NUMBER: 08-072-22

Race Cool Down Feature Inoperative

This bulletin involves installing a hood latch, adding a hood latch switch jumper harness and a Body Control Module (BCM) Reconfiguration.

2021 (DT) RAM 1500 Pickup

Fig. 1

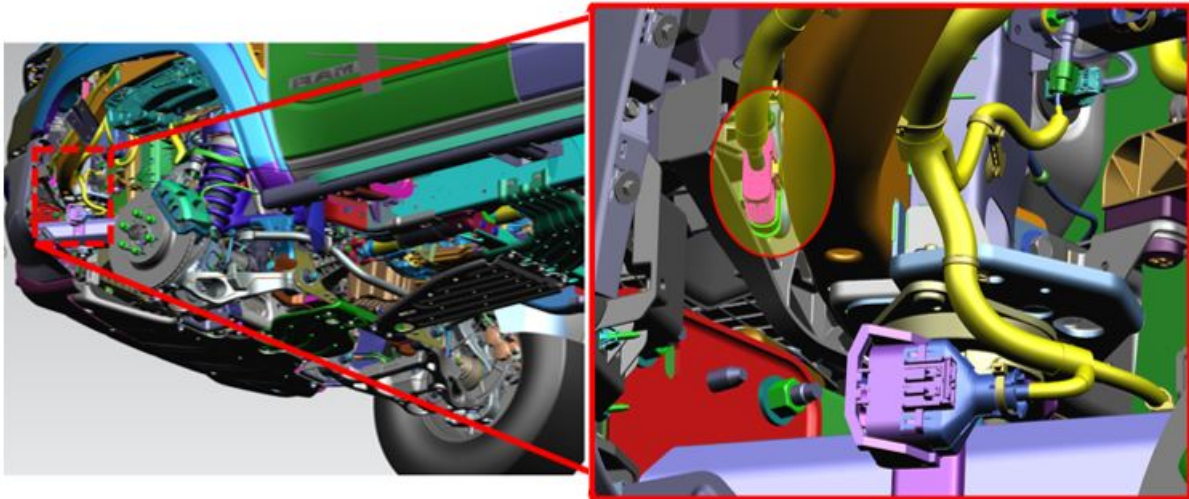
1. Replace the hood latch switch. Refer to the detailed procedures available in DealerCONNECT > Service Library> under: 23 - Body / Hood / Latch, Hood / Removal and Installation.
2. Remove the left front tire and splash shield to gain easy excess to main harness connector XY110A (Fig. 1) .

Fig. 2
Hood Latch and Harness

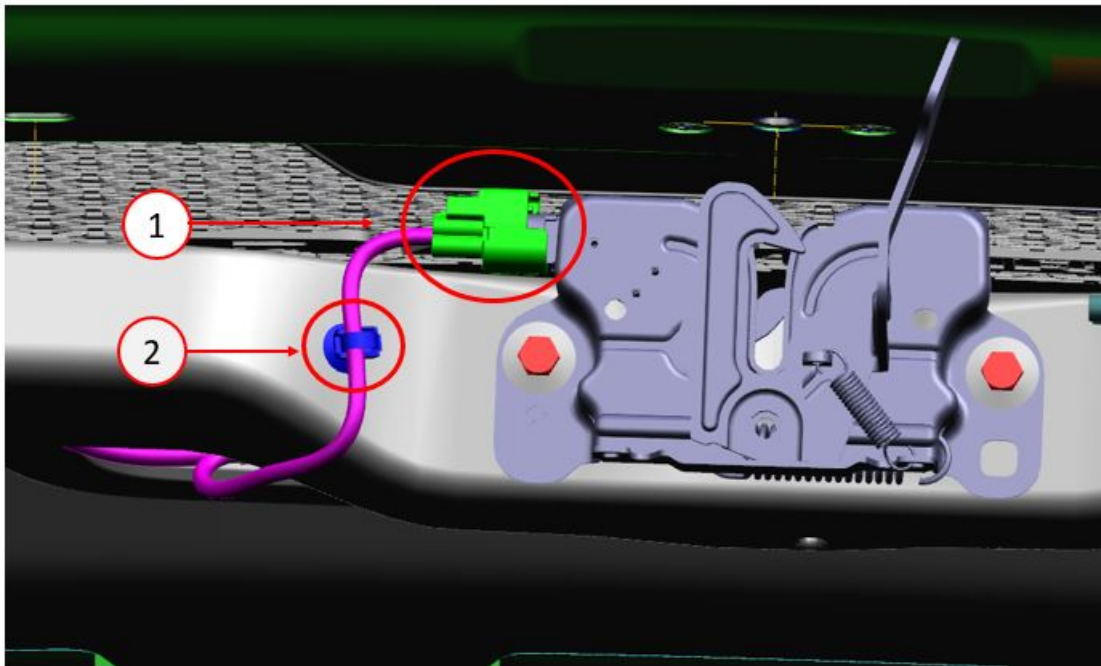
5. Secure the jumper harness to the headlamp harness using Tesa tape (51036) or equivalent. Install a wire harness clip next to the latch (Fig. 2).

Fig. 3
Back View of Crossmember

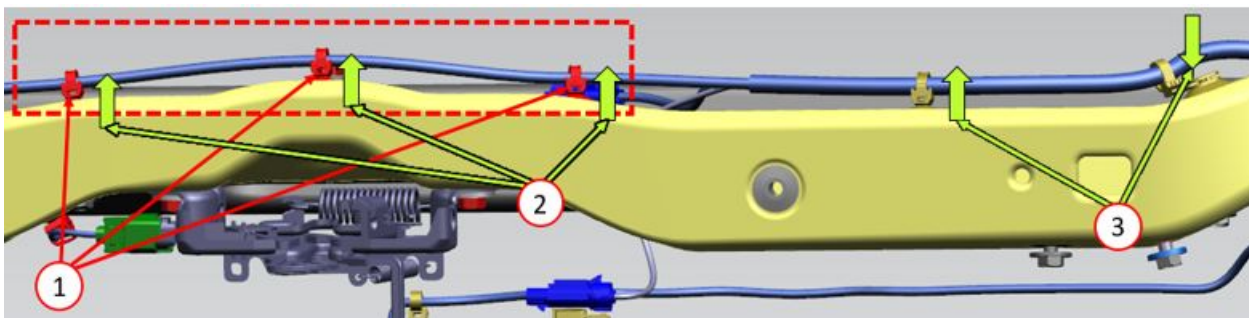
NOTE: If the three Xmas tree clips are missing in figure (Fig. 3) call out number one, use the three new clips in the jumper harness kit to attach the jumper harness.

7. Add a tie straps to hold the jumper harness to the main harness next to the existing Xmas tree clips (Fig. 2).

Fig. 4
Run Harness Behind Radiator Support

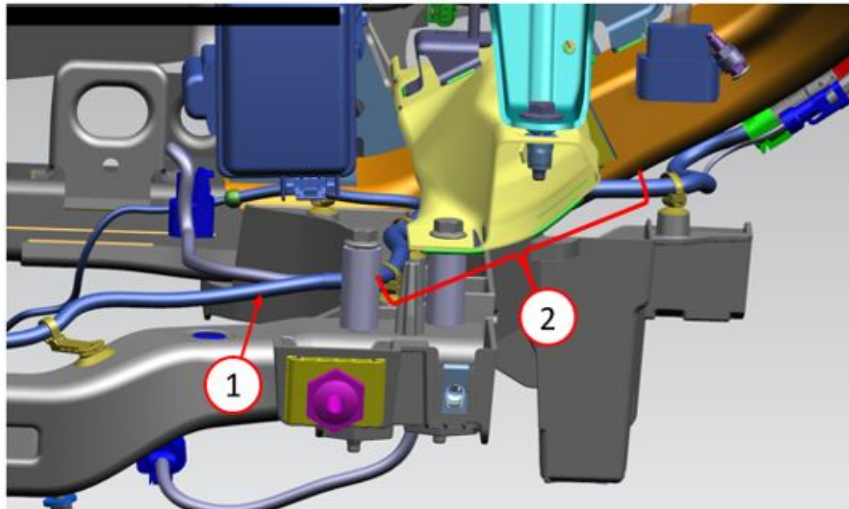
8. Add tie strap to hold jumper harness to main harness and run the jumper harness behind the radiator support (Fig. 4) .

Fig. 5
Connector Clip/Retainer Location

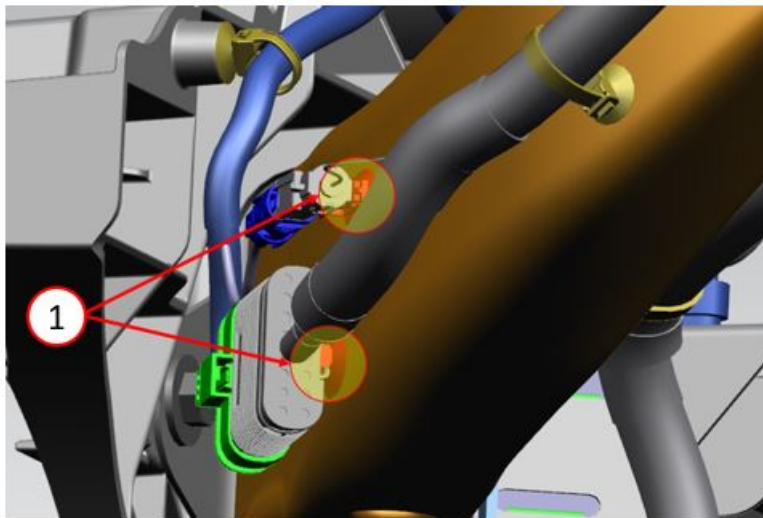
9. Carefully unclip both connections from cross member and insert the loose pins from the jumper harness in to connector XY100A (Fig. 5) .

Fig. 6
Connector Cavity Location

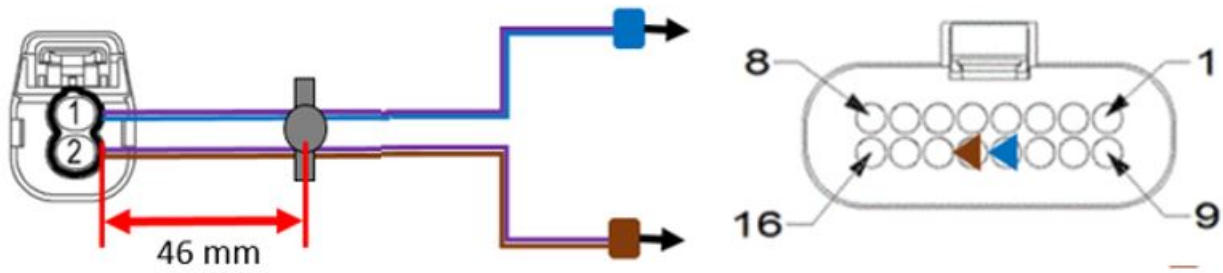
10. Remove the two cavity plugs from cavity 12 and 13, connector XY110A (Fig. 6) .

11. Insert the circuit from cavity one of the hood latch connector and put that circuit in cavity 12 of connector XY110A.
12. Insert the circuit from cavity two of the hood latch connector and put that circuit in cavity 13 of connector XY110A.
